**NOTICE OF A REGULAR MEETING
BONDURANT PLANNING AND ZONING COMMISSION
SEPTEMBER 8, 2022**

TITLE: -RESOLUTION NO. PZ-220908-25: Considering recommended approval of the site plan for the Midstates Precast Products parking lot and office project at 2340 Hubbell Avenue SW

TITLE: - RESOLUTION NO. PZ220908-26: Considering recommended approval of the Amazon Truck Wash site plan at 2300 Shiloh Rose Parkway SW

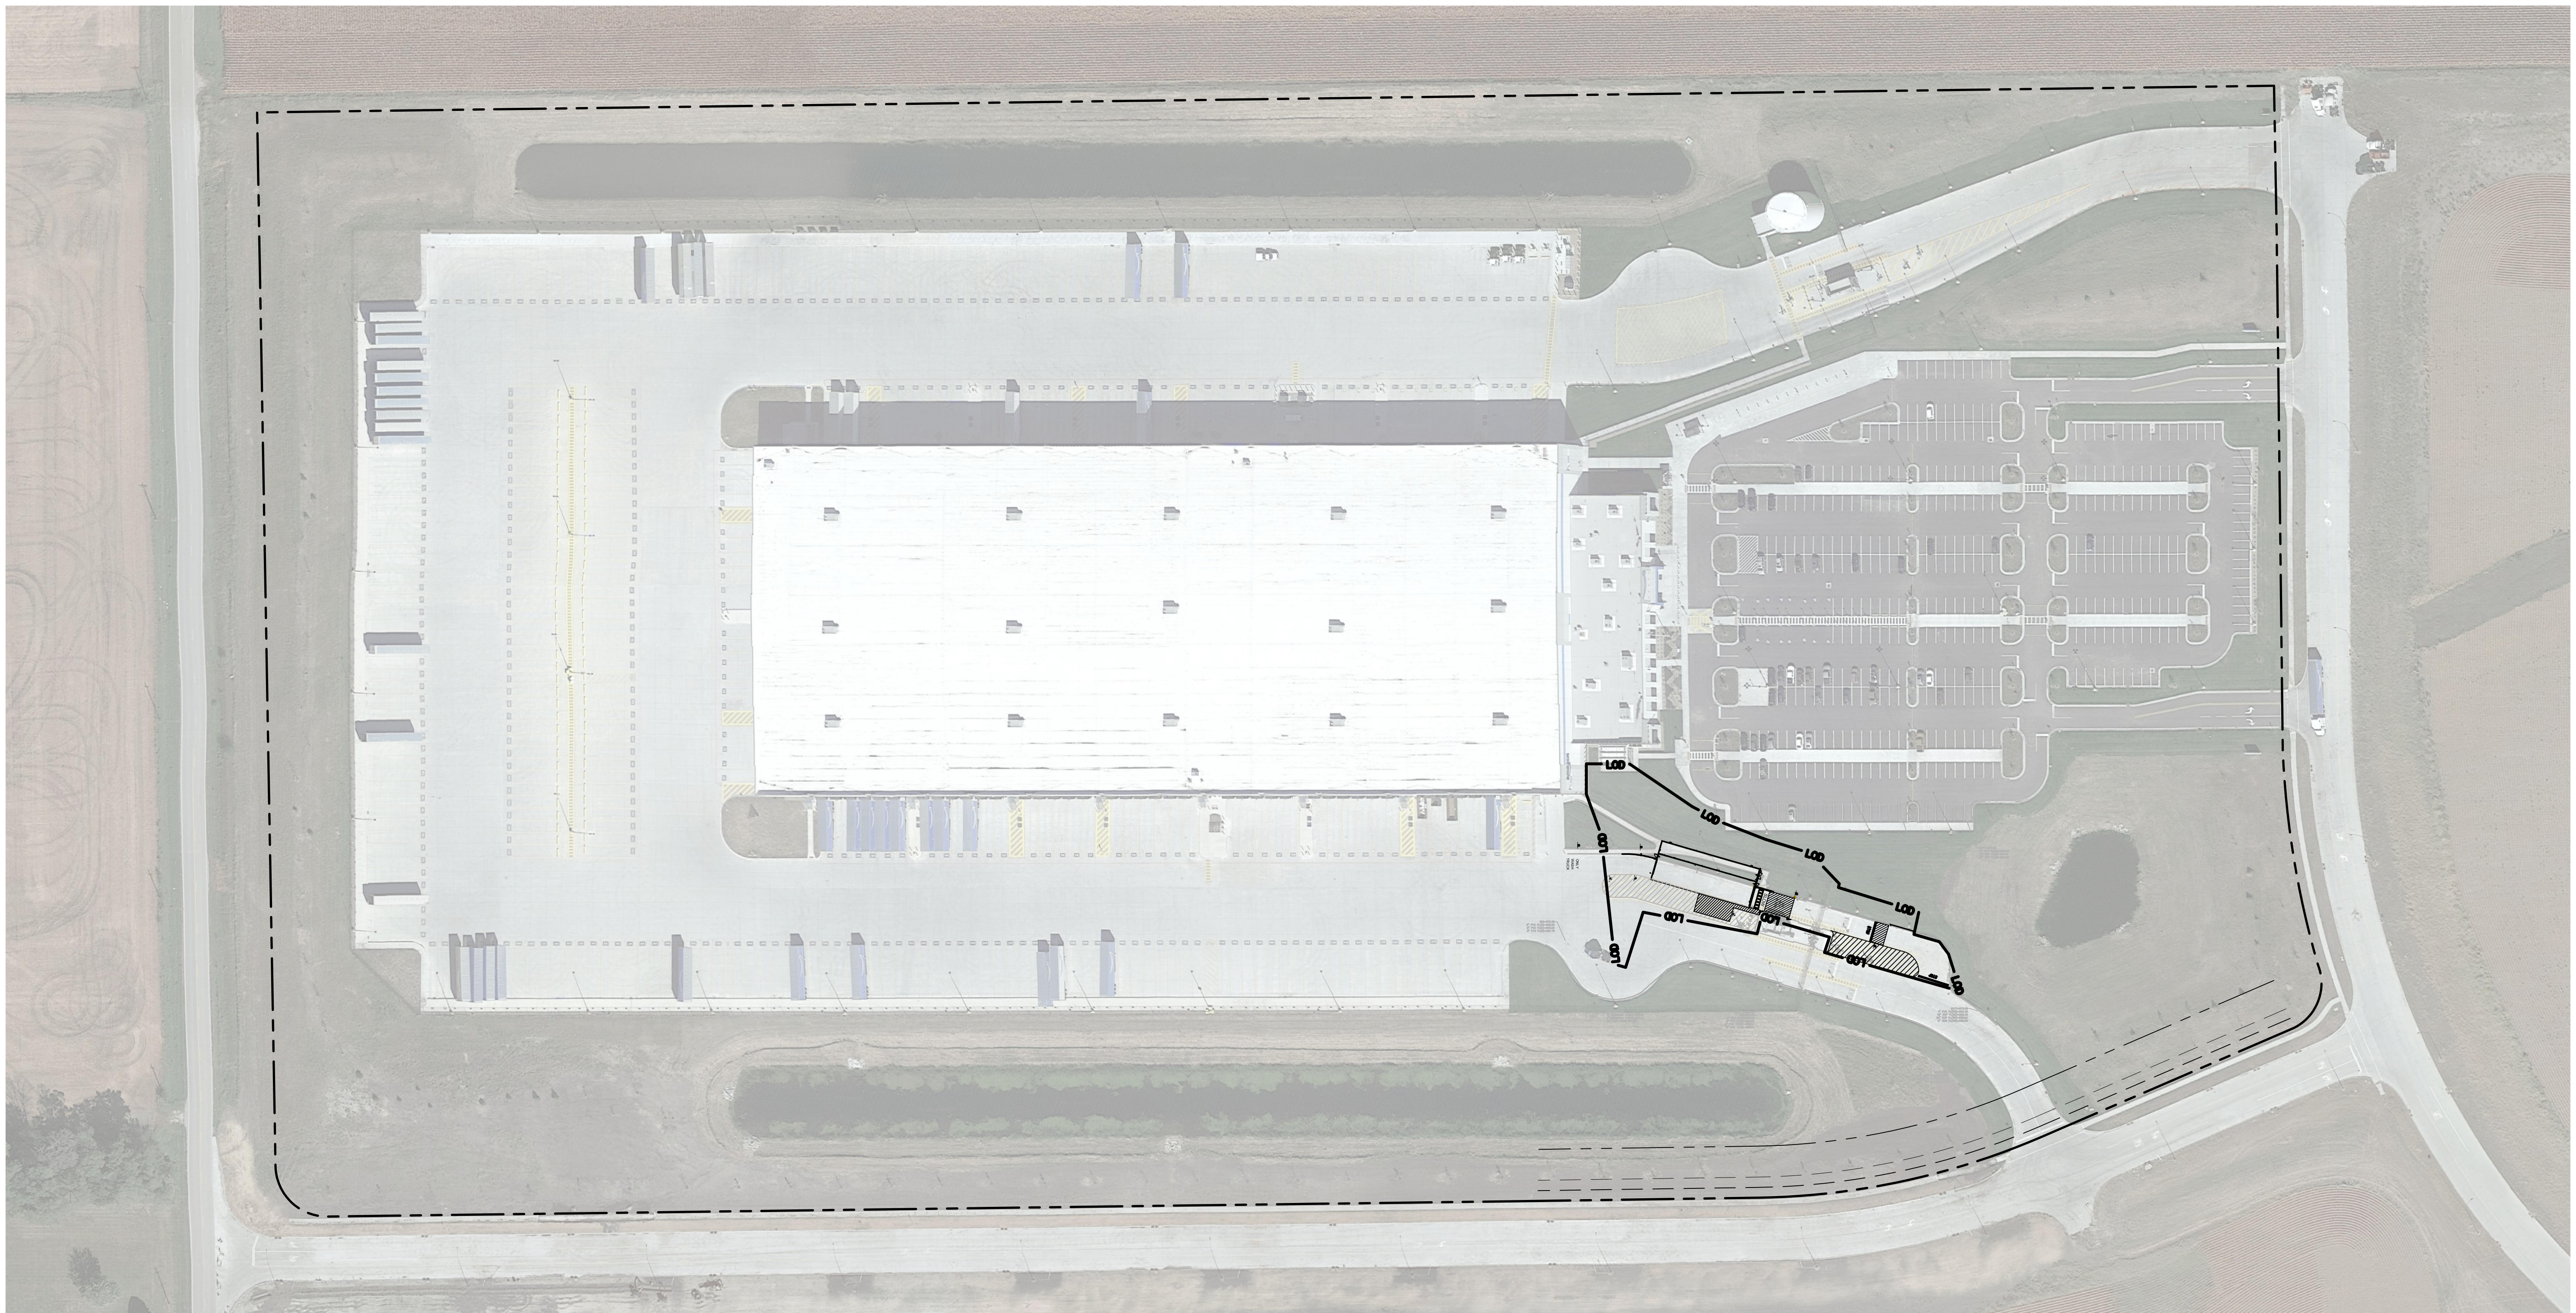
- The site plan does not show any new exterior dumpster proposed as a result of this truck wash project. If one is proposed, the site plan must be updated to show location and note screening materials.
- If applicable, sign permit to obtain sign permit(s) prior to sign installation work.

2. That the site plan be updated to note total impervious surface square footage information.

REVISIONS	Desc.
No.	Date
Designed	B.H.H.
Drawn	B.H.H.
Reviewed	J.C.J.
Scale	AS SHOWN
Project No.	2200424.04
Date	07/08/2022
CAD File:	GU220042401
Title	GRADING & UTILITY PLAN
Sheet No.

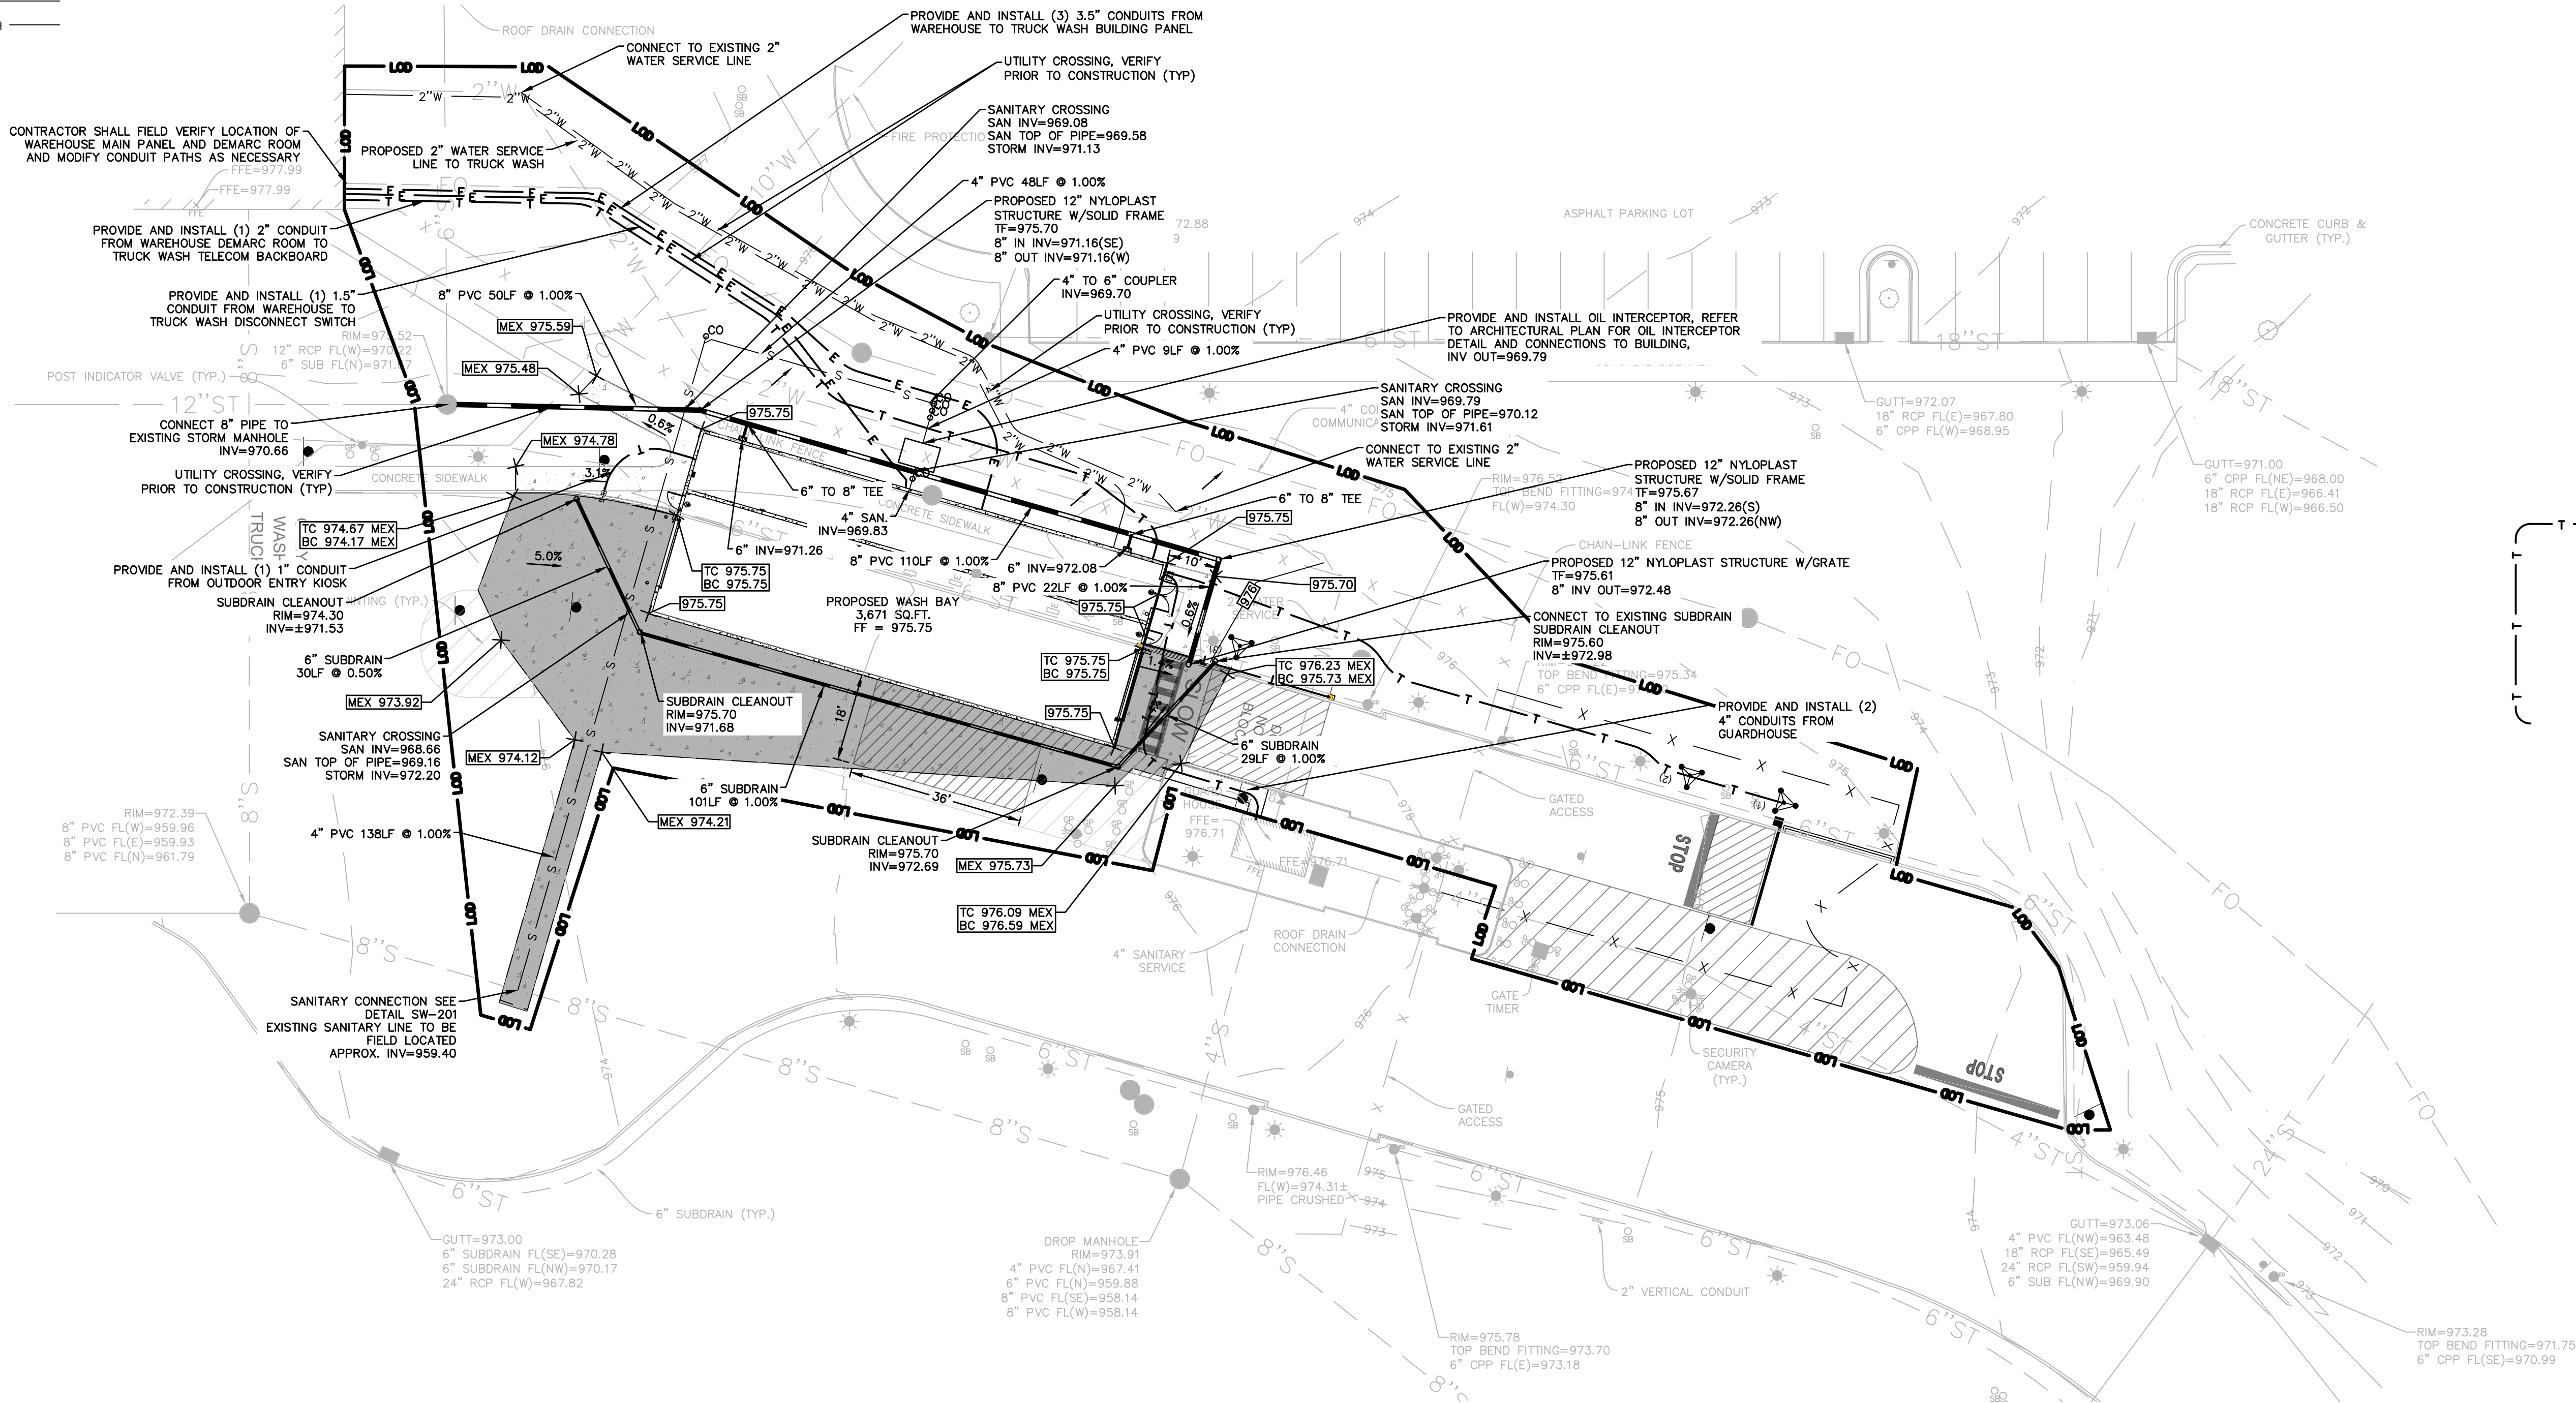
- The site plan shows an 8" storm sewer located on the northerly side of the building. The storm sewer connects to an existing storm sewer located west of the northwest corner of the building. The storm sewer extends east along the north side of the building and south to an intake located just north of the driveway. In addition, roof drains are shown.
- The site plan shows relocation of the existing 2" water service that is located near the northerly side of the truck wash facility. In addition, a new 2" water service is being extended to the truck wash facility.
- A 4" sanitary sewer is extended from the from the existing sanitary sewer located south of the southwest corner of the truck facility.

1. That the site plan be updated to accommodate the City Engineer's review comments.
